**DEPARTMENT OF TRANSPORTATION  
STATE OF GEORGIA**

**SUBJECT** APPROVED REVISED CONCEPT REPORT

**DEPARTMENT OF TRANSPORTATION  
STATE OF GEORGIA  
REVISED PROJECT CONCEPT REPORT**

**Subject:** *Revised Concept Report Review Comments*

## TYPIICAL SECTION

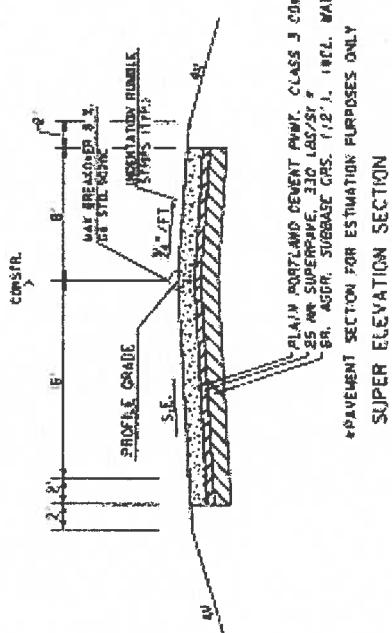
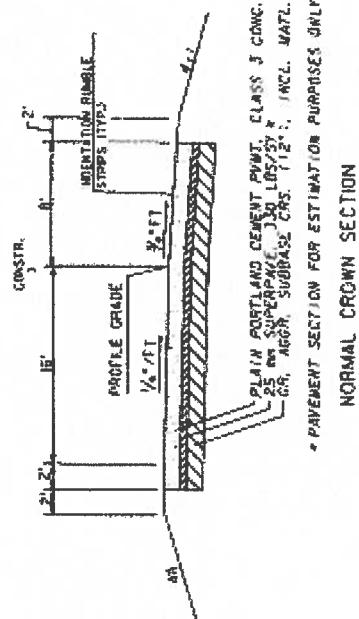
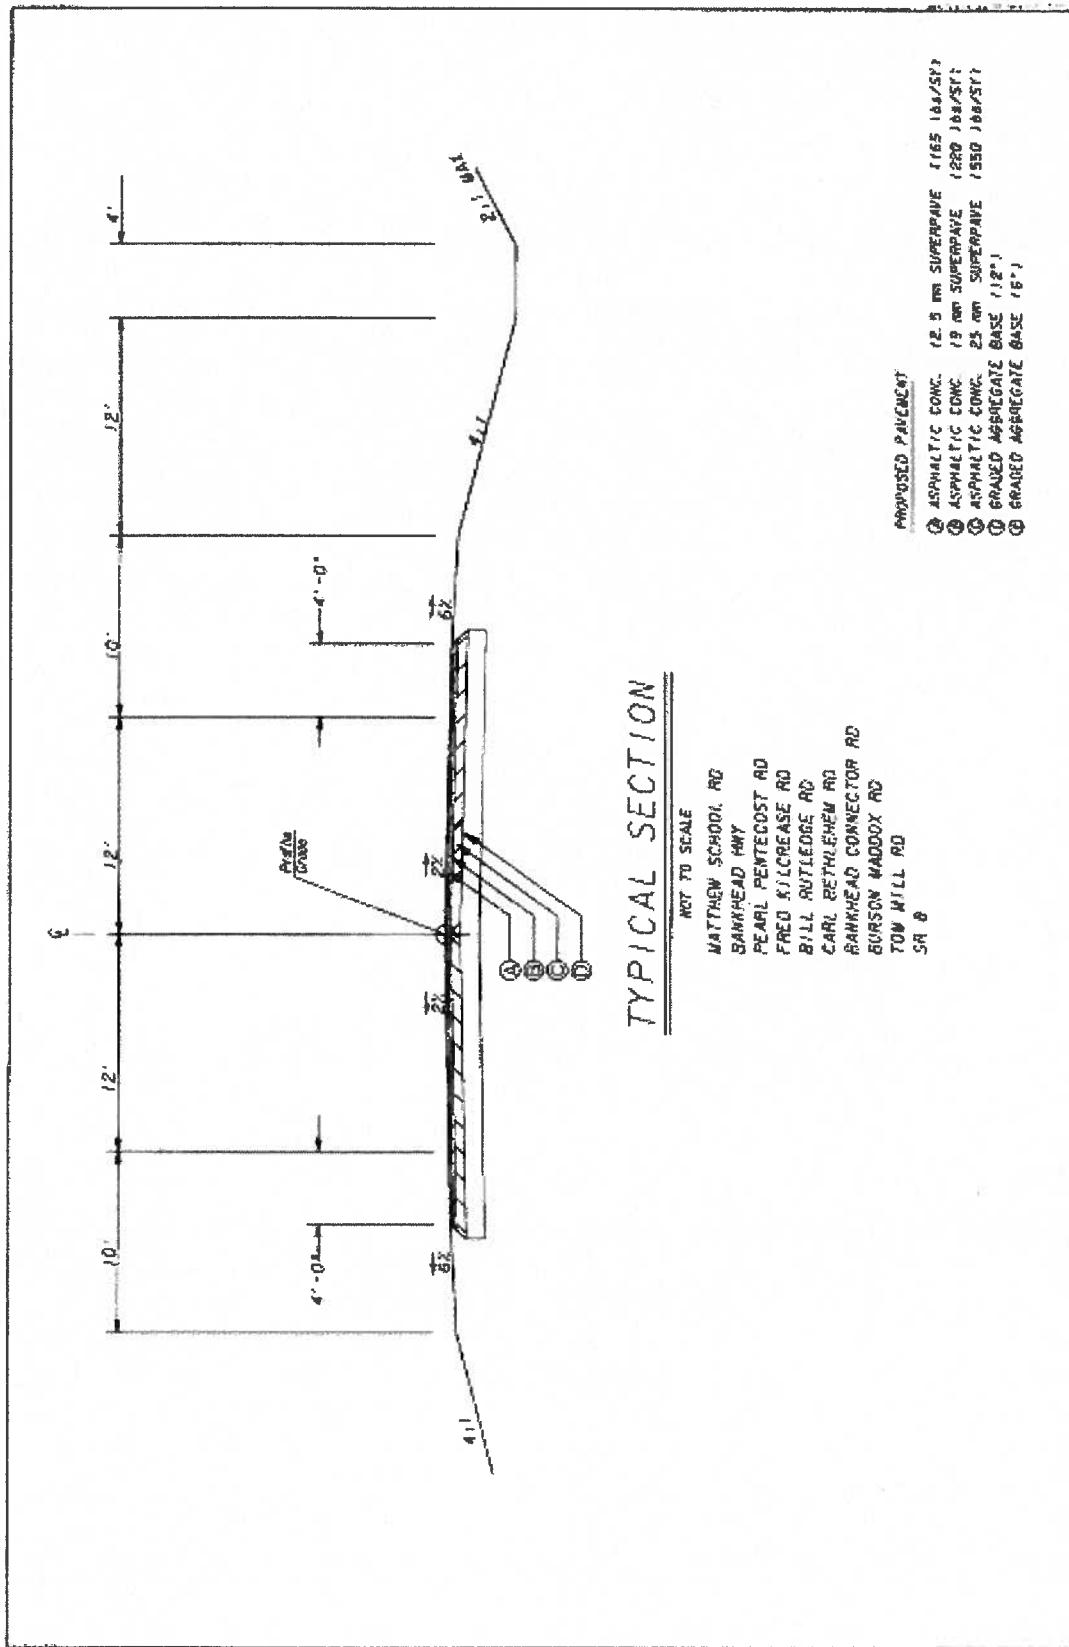
Comment 4. Check roadway typical section vs. bridge typical section. Raised median width does not appear to match.

Response: Alternate No. 17 of the Value Engineering Study Alternatives suggests reducing the width of the median from 24-feet to 20-feet. The implementation letter states this will be implemented except at intersections, where the median will remain 24-feet to offset left turning movements. The typical section for the bridge has been revised to reflect the 20-foot raised median.
